ADDENDUM NO. 3

Project Name: Kroegel Homestead Improvements

Bid Number: 2021007

Updated Plan Sheet C5

SHEET **C5**

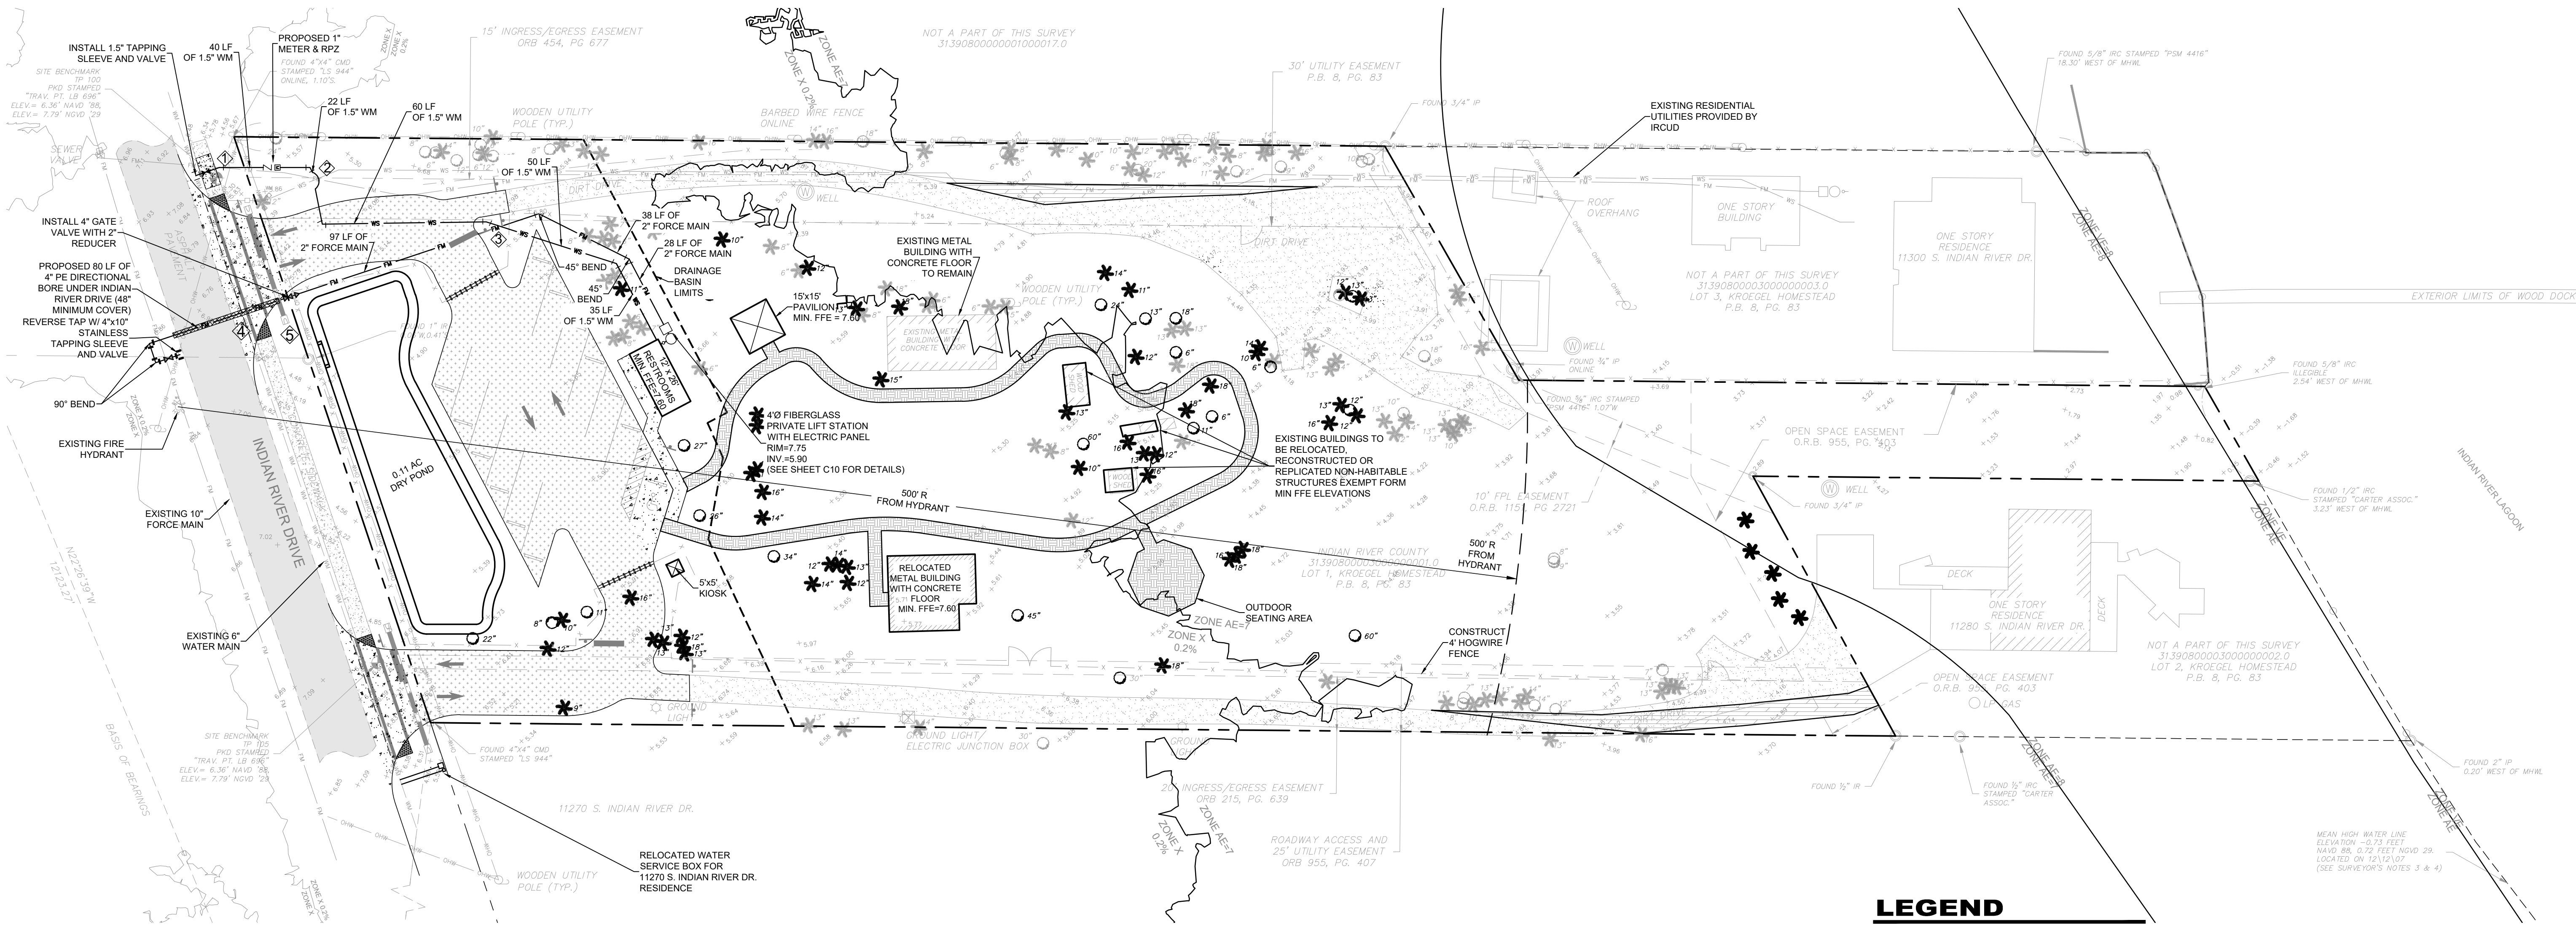
The lift station and sewer testing are removed from the scope of work, per the attached modified plan sheet.

1. CONSTRUCTION OF THE BATHROOM BUILDING AND LIFT STATION WILL NOT BE CONSTRUCTED WITH THIS PROJECT, BUT UNDER A SEPARATE, LATER PHASE. WATER AND SEWER SERVICES WILL BE BROUGHT TO APPROXIMATELY 3 FEET OUTSIDE OF BATHROOM BUILDING FOR THIS PROJECT. ALL WATER AND SEWER TESTING WILL BE COMPLETED AT THE TIME OF CONNECTION TO THE BATHROOM FACILITY.
